ROAD SAFETY AUDIT RESPONSE

Report title:	Knowsley Business Park Section 278 works – Road Safety Audit Stage 1/2 – Designer's Response
Date:	9 June 2025
Document reference and revision:	22075-BGL-XX-XX-TN-C-00003 P01
Prepared by:	Burrows Graham Limited
On behalf of:	Knowsley Council

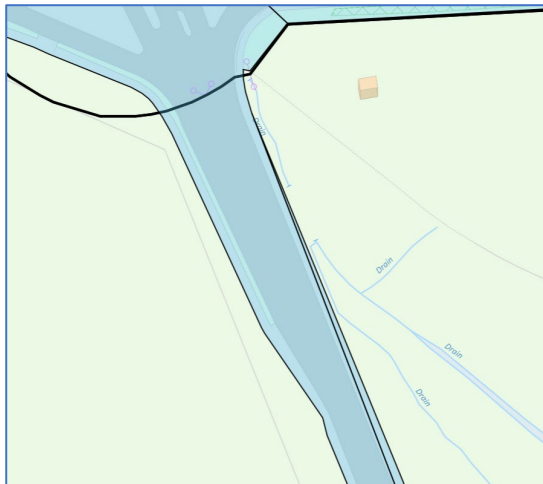
Ref	RSA Problem	RSA recommendation	Design Organisation Response	Overseeing Organisation Response	Agreed RSA Action	
3.1	LOCATION: Ormskirk Road SUMMARY: Lack of suitable linkage to surrounding shared footway/cycleway facilities may pose as a hazard for cyclists leading to rider injury. In the vicinity of the development site, there is a dual use footway/cycleway along the southern side of the A580 with a toucan crossing facility across Ormskirk Road arm of the traffic signal junction. There is also a dual use footway/cycleway route along the northern side of the A580 into Coopers Lane. The proposal includes for a section of shared footway/cycleway along the eastern side of Ormskirk Road, however the northern end of the proposed route does not tie in with the existing dual use footway/cycleway route along the A580 leaving a missing section of approximately 80m and the opportunity to use the controlled crossing facilities at the traffic signal junction. The Audit Brief includes the following strategic decision that it is understood to have been accepted by Knowsley Council. 'The proposed cycleway cannot be extended north to facilitate a connection to the facility at the existing A580 East Lancs Road & A5208 Coopers Lane signal controlled junction. To sufficiently widen the existing footway to form a shared pedestrian/cycleway will require land outside of the developer's ownership, land that was also outside of the planning application boundary. The planning application made clear that this connection would not be delivered. Given the application was approved, there is no planning need for this connection. The drawings submitted for safety audit follow the principles approved in the planning application'. However, the RSA Team are concerned that the proposed dual use route has been designed for cyclists travelling southbound only and has not taken into consideration how cyclists travelling northbound will return back to the carriageway and the ability to join the existing dual use facility on the A580 if they wish to do so. The lack of suitable transition back to the carriageway may lead to cyclists being hit by vehicles. Alternatively, cyclists may continue on the footway. This may lead to pedestrian to cyclist collisions leading to pedestrian injury.	 ROAD MARKINGS TO GUIDE CYCLISTS ONTO SHARED FOOTWAY / CYCLEWAY TO BE BACK AT TR FOOT 3.0m FOOTW 2.4m LADDER	It is recommended that northbound cyclists are provided with an appropriate facility to allow them to safely return to the carriageway. The cycle dismount sign should be replaced with 'cyclists rejoin carriageway 'as recommended in LTN 1/20. However, it may be appropriate to cutback the vegetation encroaching at the back of the footway and widen the existing footway within the available highway boundary to link the existing and proposed route, albeit a substandard width to minimise rider conflicts with vehicles, and / or pedestrians. It is noted that the shared use route around the radii of the traffic signal junction is less than the minimum recommended and is also further narrowed by the pedestrian guard railing.	Disagree. The back of the footway is the highway boundary, as shown in the extract below from Knowsley Council's map. There is therefore no scope to widen the existing footway and Knowsley Council has accepted that this area falls outside the scope of the S278 works. Cycle dismount sign are no longer proposed but the "end of route" sign is still proposed for northbound cyclists. Please see the drawing extract below showing back to back signs to be installed at the northern end of the shared use route.    END OF ROUTE

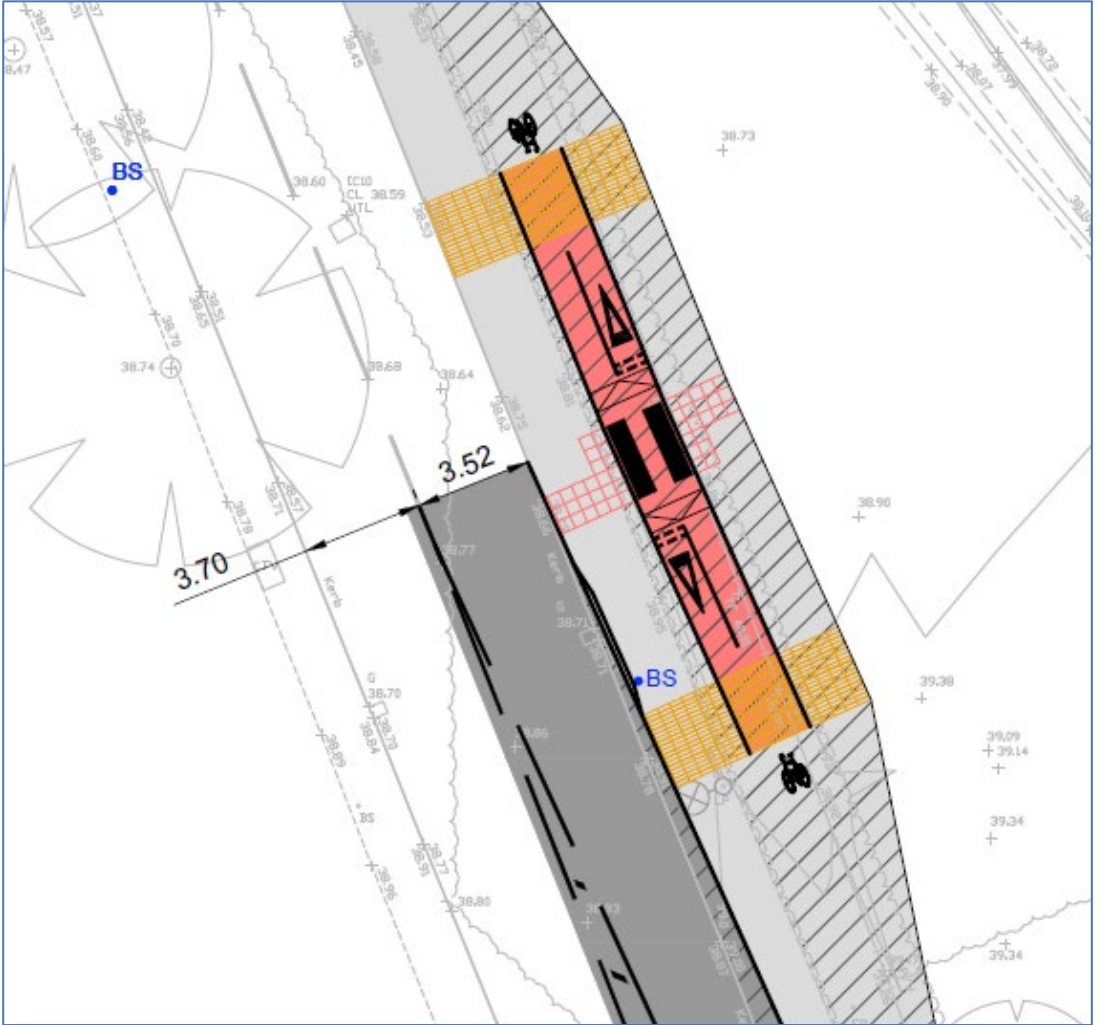
Ref	RSA Problem	RSA recommendation	Design Organisation Response	Overseeing Organisation Response	Agreed RSA Action
3.2	LOCATION: Southbound bus stop SUMMARY: Potential conflicts between cyclists and users at the bus stop. At the bus boarder by-pass, due to the route either side of the bus boarder being shared and there being no difference in surfacing colour for the cycle section, cyclists are likely to take the direct route following the kerb edge instead of using the short section of segregated route behind the waiting area, particularly if the bus stop is not well used.	 It is recommended that if a bus boarder bypass is required, the cycle lane section should be of a contrasting colour to the footway and waiting area, and cycle symbols added to guide cyclists to follow the route behind the bus stop. It is acknowledged that recent research carried out by TfL indicates that there is a low risk of conflicts between bus passengers and cyclists at bus boarders.	Problem and recommendation accepted. Bus boarder bypass insisted upon by Merseytravel. Green coloured asphalt to be laid within the cycle lane section and cycle symbols to be painted. Please see the drawing extract below showing the location of cycle symbols and the extents of the green coloured asphalt in pink.

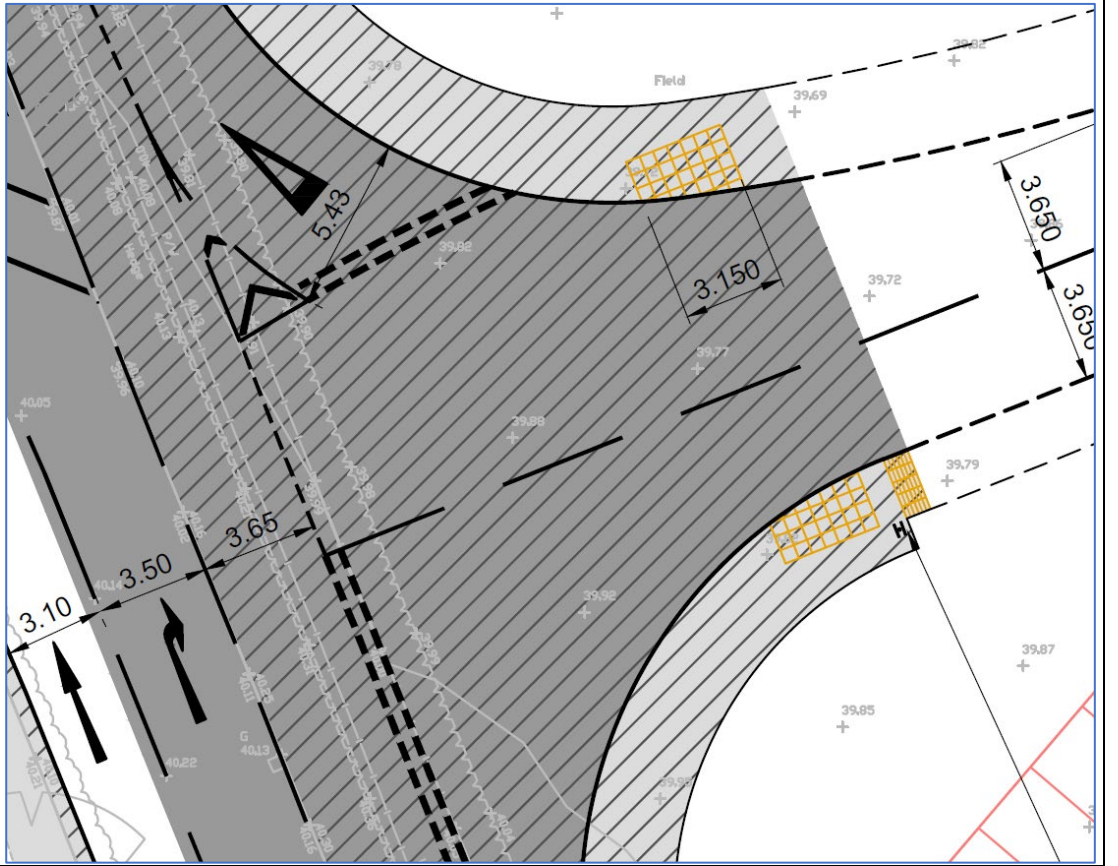
Ref	RSA Problem	RSA recommendation	Design Organisation Response	Overseeing Organisation Response	Agreed RSA Action
3.3	LOCATION: Uncontrolled crossing across site access SUMMARY: Narrow crossing point potential conflicts between users leading to injury. The proposed width of 1.6m for the shared use crossing facilities at the access is narrower than the recommended latest design advice. Insufficient width to allow users to pass one another at the crossing may lead to pedestrian to cyclist or cyclists to cyclists collisions. 	It is recommended that the width of the crossing point is increased to 3m.	Problem and recommendation accepted. Width of crossing point increased to 3.15m to prevent the 0.45m² tactile paving slabs from needing to be cut. Please see the drawing extract below.

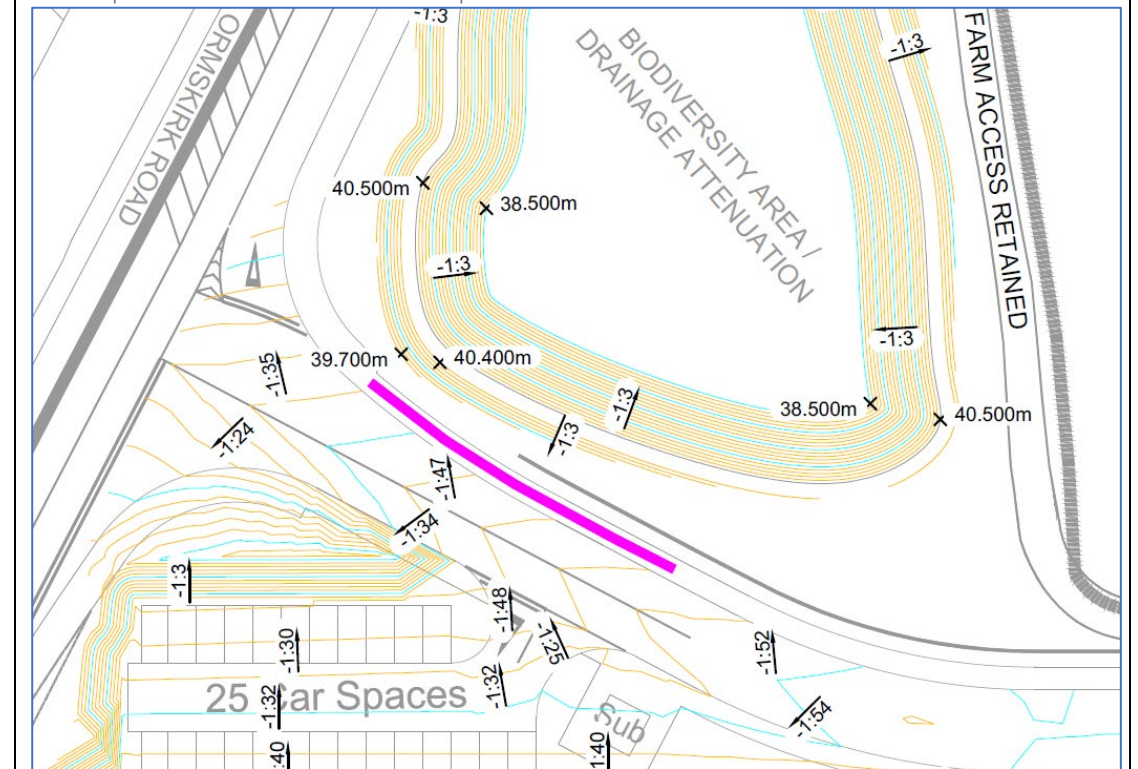
SUMMARY: Risk of cyclists being hit and injured by vehicles.

The shared footway/cycleway does not extend into the development with the facility starting/terminating at the junction. Cyclists who rejoin the carriageway at the crossing point may be vulnerable to being hit by vehicles turning into the junction. In particular, by left turning vehicles whose drivers are likely to be concentrating on looking to the right towards vehicles turning off Ormskirk Road as they need to give way to them.

The start of the shared facility for cyclists travelling along the development access road towards Ormskirk Road may not be easily identifiable and they may end up missing the start of the facility and have to negotiate the junction instead with the potential of being hit and injured by passing vehicles.

It is recommended that the shared route on both sides of the development access road is extended further into the development away from the potential conflict with manoeuvring vehicles at the junction. Appropriately positioned lengths of dropped kerbs should be provided to allow cyclists to rejoin/leave the carriageway. The start/end of the route should be clearly identifiable. This may include the use of cycle markings (cycle logos, give way lines and arrows). The cycle dismount sign should be replaced with 'cyclists rejoin carriageway' as recommended in LTN 1/20.

Problem accepted. Recommendation partially accepted. The shared use route will be extended into the site on the northern side of the access road, as shown indicatively by the pink line in the markup below. Dropped kerbs, a short section of carriageway cycle lane markings, a cycle symbol and signage will be provided to allow cyclists to rejoin the carriageway. These works will be carried out on private land and will not form part of the S278 extents. The shared use route cannot be extended into the site on the southern side of the access due to internal site constraints (a 1:3 embankment from the car parking spaces) but a short section of carriageway cycle lane markings and a cycle symbol will be added to the westbound lane and dropped kerbs will be added on the southern side of the road to enable cyclists exiting the development to join the shared use route. These works will also be carried out on private land and will not form part of the S278 extents.

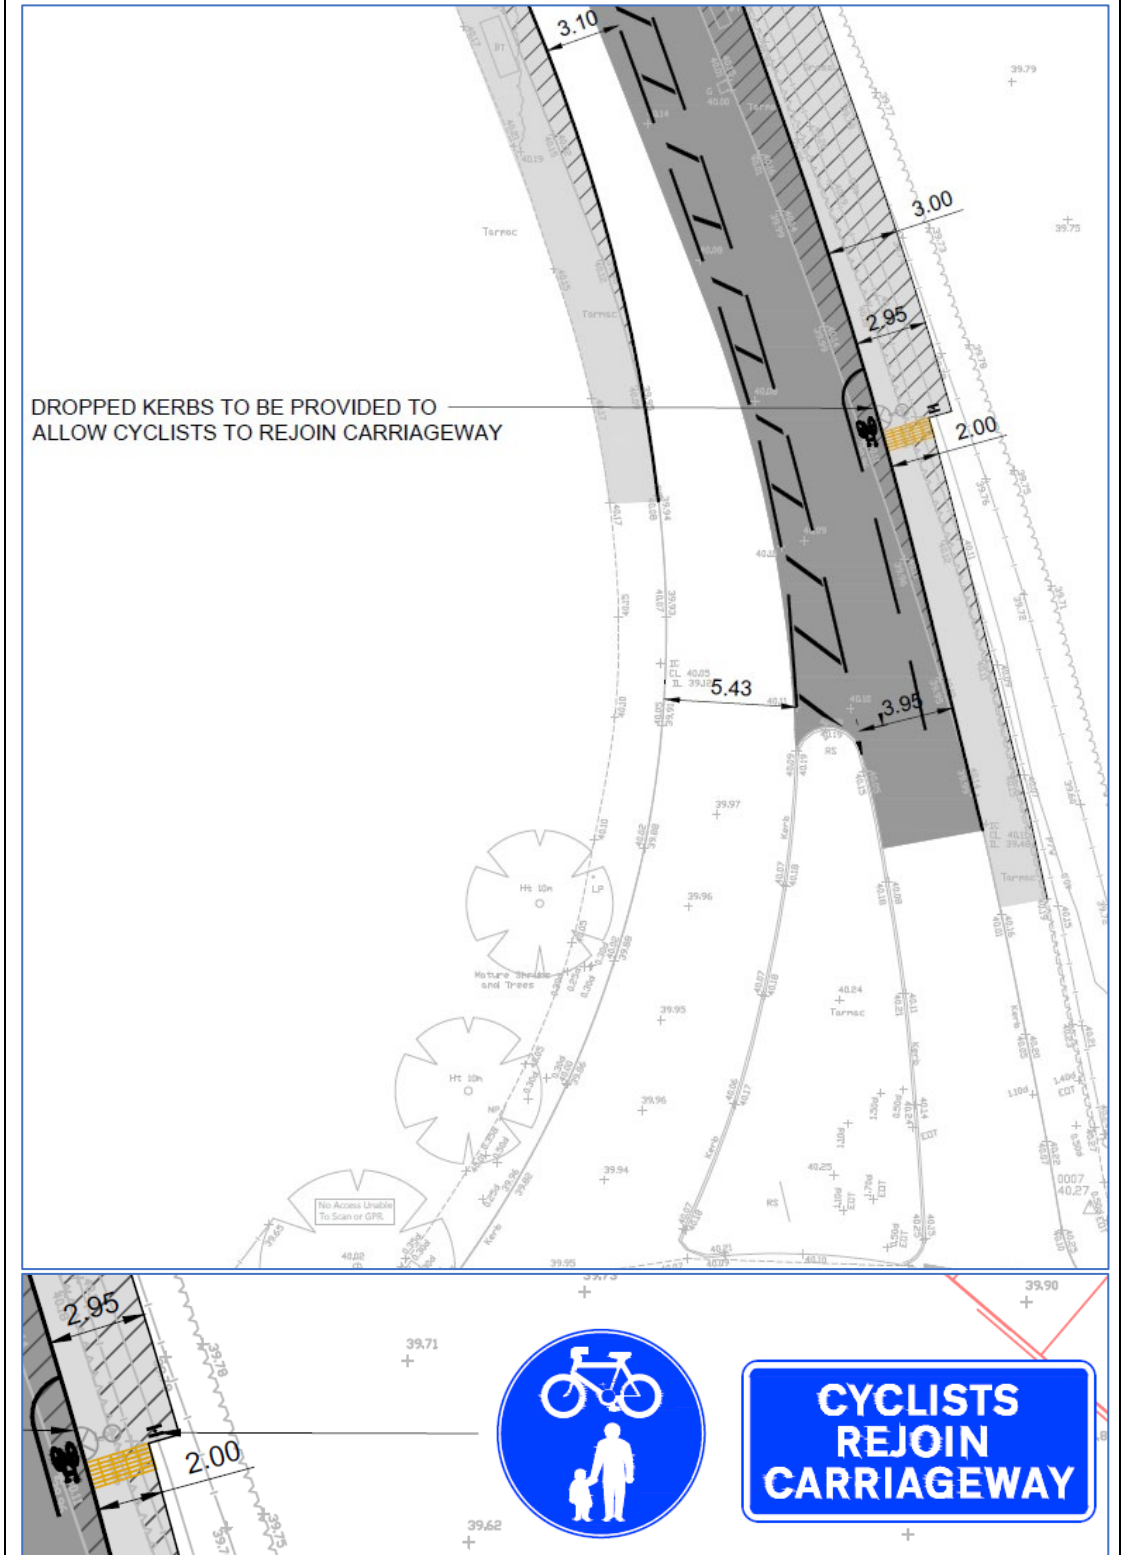
SUMMARY: Risk of cyclists being hit and injured by vehicles.

The width of the approach to the roundabout is a wide single lane and cyclists rejoining the carriageway at this location may be vulnerable to being struck by overtaking vehicles. Cyclists may also find it difficult to position themselves correctly at the roundabout in relation to which exit they are travelling to, particularly during peak periods or when vehicles are queuing back from the junction.

It is recommended that the end of the route is relocated further north to enable cyclists to position themselves in the correct position prior to the junction. It may also be appropriate to highlight to drivers that cyclists are returning to the carriageway by providing a short length of on-carriageway cycle lane markings. The cycle dismount sign should be replaced with 'cyclists rejoin carriageway' as recommended in LTN 1/20.

Problem and recommendation accepted. End of route to be relocated approximately 30m north from current proposed location to allow cyclists to rejoin the carriageway by means of a short length of on-carriageway cycle lane markings before the splitter island. The signage has also been amended as per the auditors' recommendation. Please see the drawing extracts below.

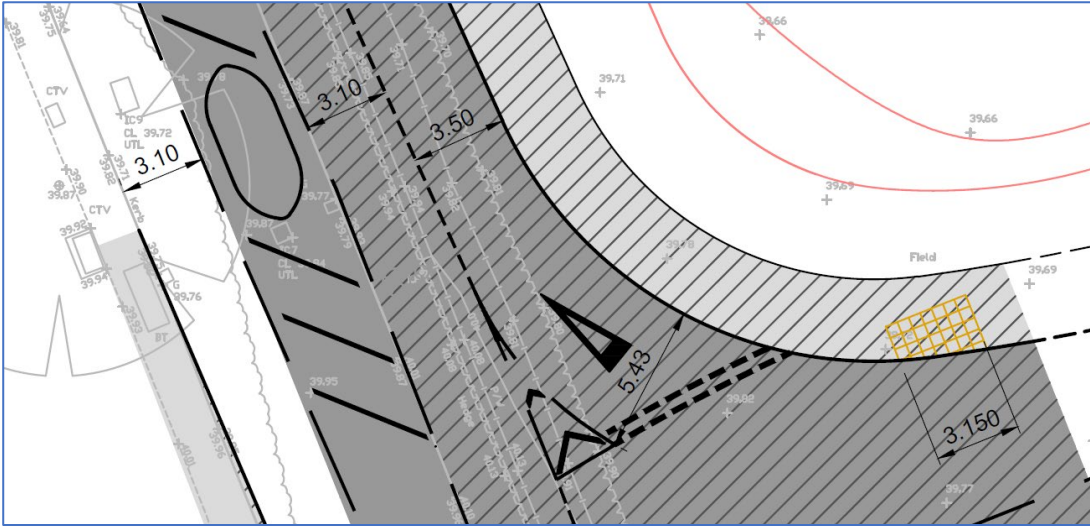
3.8	LOCATION: Site Access SUMMARY: Drivers striking kerb lines of splitter island may lead to loss of control type collisions. The splitter island segregating the through lane and the auxiliary lane is located close to the edge of the running lane and is likely to be at risk of being hit by passing vehicles. This may lead to kerb strikes and tyre damage as a result, which may lead to tyre blow-outs and loss of control type collisions elsewhere on the highway network.		It is recommended that the splitter island should be setback a minimum of 1m from the edge of the running lane.	Problem accepted. Alternative solution suggested. Island to be defined by road markings as a setback would make a physical island too small to allow sufficient clearances to its bollard. Please see the drawing extract below.

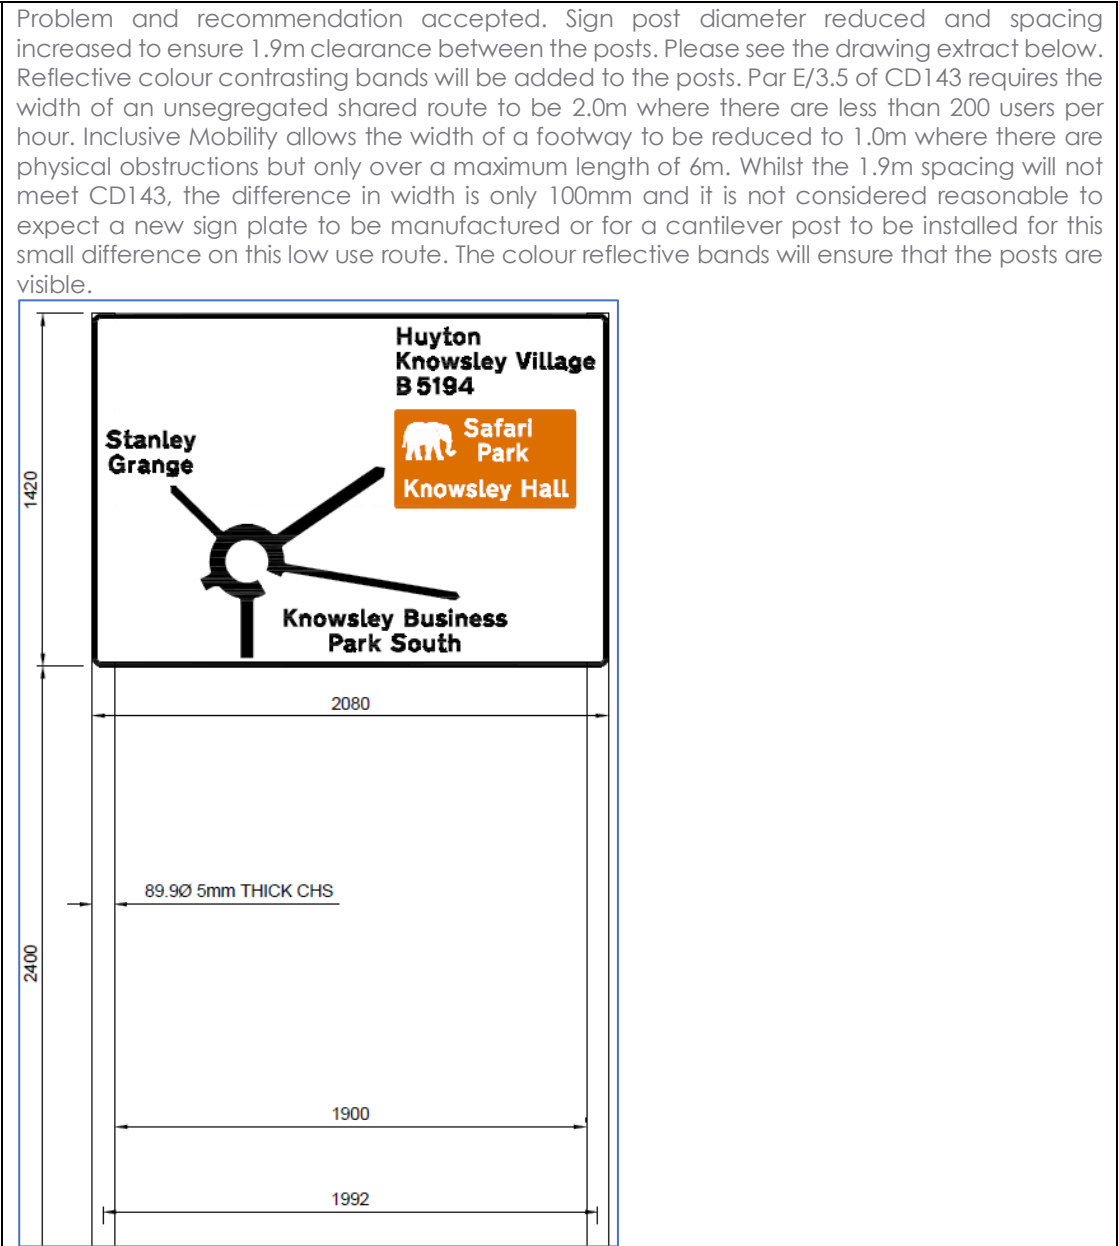
3.9	LOCATION: Site Access SUMMARY: Cycle to vehicle collisions, involving vehicle overtaking manoeuvres. The traffic lane widths through the ghost island junction, passed the pedestrian refuge island and traffic island are 3.65m wide. Gaps of 3.1 to 3.9 metres are the least satisfactory from a cyclist's perspective, as a driver may perceive that the carriageway is wide enough to overtake a cyclist through the refuge/traffic island, which may result in a cyclist being squeezed and hit.		It is recommended that lane widths between 3.1m and 3.9m should be avoided, to safeguard cyclists at gaps. It is acknowledged that swept paths may require that the traffic lanes through the junction are wider than desirable for cycle safety, therefore it may be appropriate to visually narrow the lane widths by widening hatched markings.	Problem and recommendation accepted. Lane widths amended accordingly. Please see the drawing extracts below showing the lane widths through the northern and southern islands.
